**CALAVERAS COUNTY WATER DISTRICT
JENNY LIND WATER SYSTEM
TANK A-B TRANSMISSION PIPELINE**

ADDENDUM #2

Issued: Friday, January 12, 2024

TEMPORARY
FLUSHING CONNECTION
GENERAL ARRANGEMENT

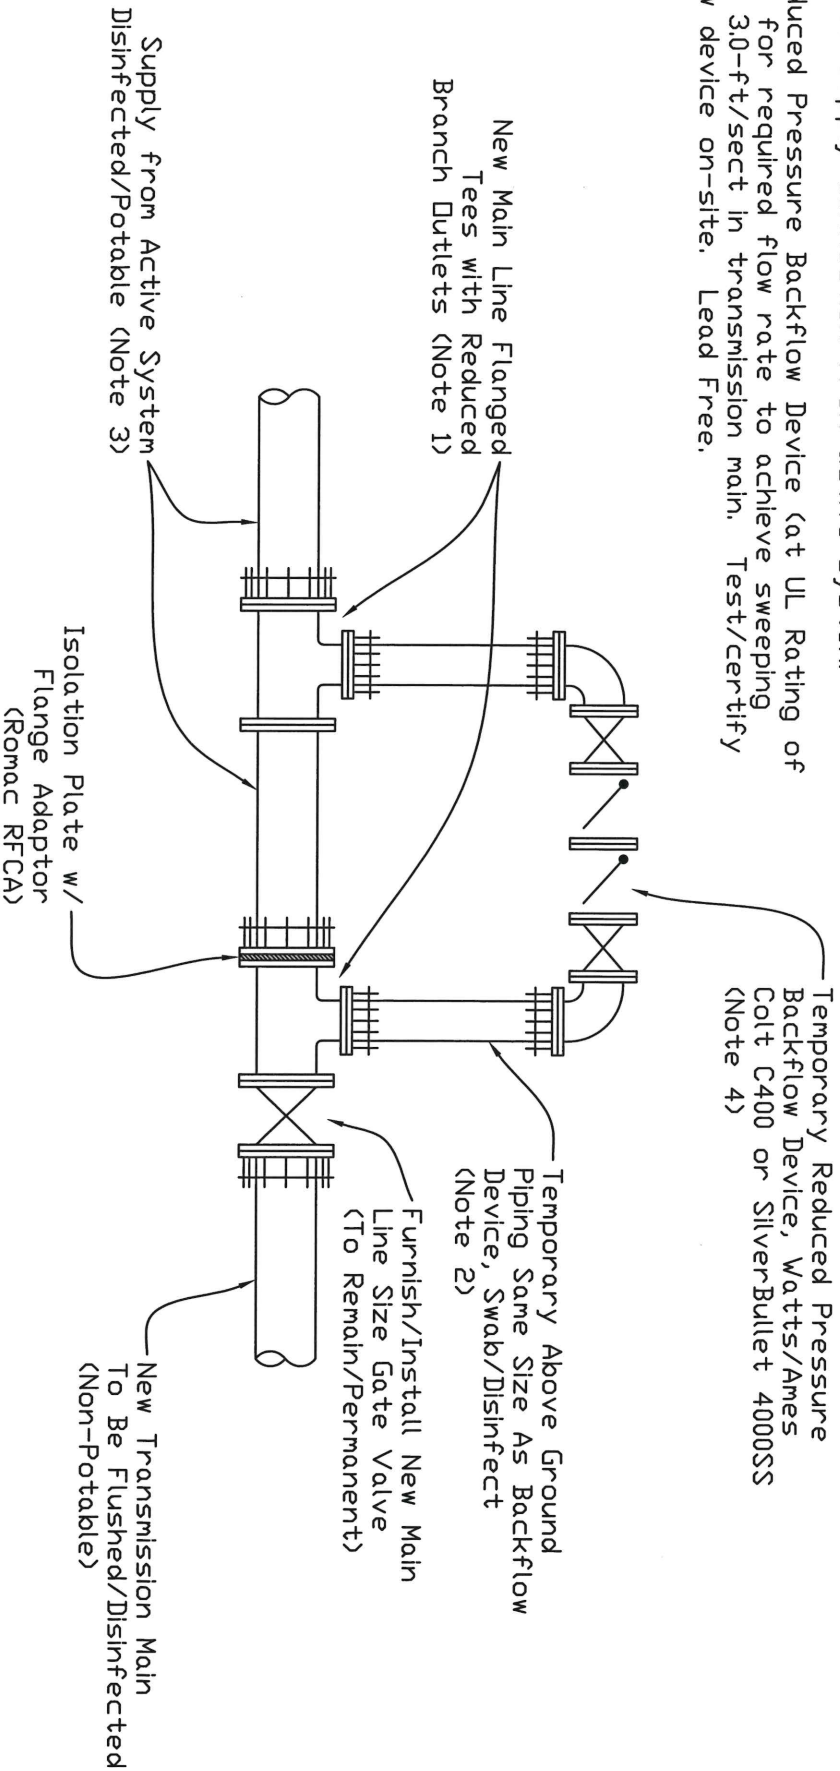
6. Appendix A / Project General Details: Add detail/requirement for temporary flushing connection with 6” reduced pressure backflow device and isolation plate. For flushing and disinfecting the new transmission main, the Contractor shall furnish and install a temporary 6” reduced pressure backflow device and isolation plate as shown in the attached detail. If an additional 14” valve is required, it shall be paid at the established unit cost.

1. Size flanged outlets same as backflow device. After removing temporary piping above ground blind flange, polywrap and bury tees in trench. Double strap tap saddles with ball corp stops may be used for 2-1/2" backflows.
2. Swab and disinfect prior to installing temporary above ground/exposed piping and backflow device. Remove all temporary piping after completing flushing, disinfection and obtaining passing bacteriological tests.
3. Contractor is responsible for tie-in connection less than 20-ft in length by swabbing with approved chlorine/hypochlorite solution or assuring fully disinfected supply connection from active system.
4. Size Reduced Pressure Backflow Device (at UL Rating of 7.5 fps) for required flow rate to achieve sweeping velocity 3.0-ft/sect in transmission main. Test/certify backflow device on-site. Lead Free.

Water Main Diameter (inches)	Flow for 3.0-ft/sect Sweeping Velocity (gpm)	Backflow Max. UL Rating (gpm)	Backflow Size (inches)	Temp. Piping Size & Type
4	120	330	2-1/2"	2"/2-1/2" Threaded*
6	265	330	2-1/2"	2"/2-1/2" Threaded*
8	470	470	3"	3" DIP
10	735	750	4"	4" DIP
12	1,055	1500	6"	6" DIP
14	1,440	1500	6"	6" DIP
16	1,878	2400	8"	8" DIP
